2 Type of change

- Change of approval rating and marking according to UL/CSA 60320-1 Standard

Product Change Notification					508X PCN		
owner	creation date	release date	released by	change order no	rev	page	D10-042-013
lokhanze	13.03.2020	18.03.2020	muehlema	2019583	B	1 of 2

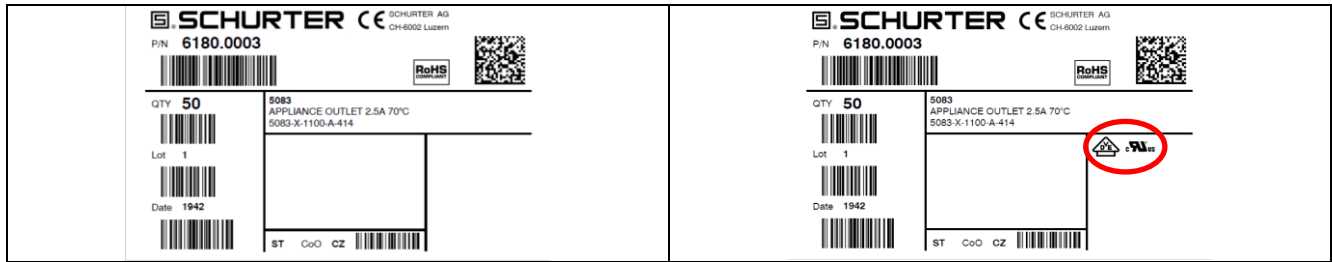
- 5083: Change of approval rating from "2.5 A / 250 V" to "7A 125VAC for cURus"
- 5083: Change of VDE approval mark position
- 5083: Change of approval marking from "cCSAus" to "cURus"
- 5084: Change of approval rating from "7 A / 250 V" to "7A 125VAC for cURus"
- 5086: Change of approval rating from "7 A / 250 V" to "7A 125VAC for cURus"
- 5088: Change of approval rating from "4 A / 250 V" to "7A 125VAC and 2.5A 250VAC for cURus"
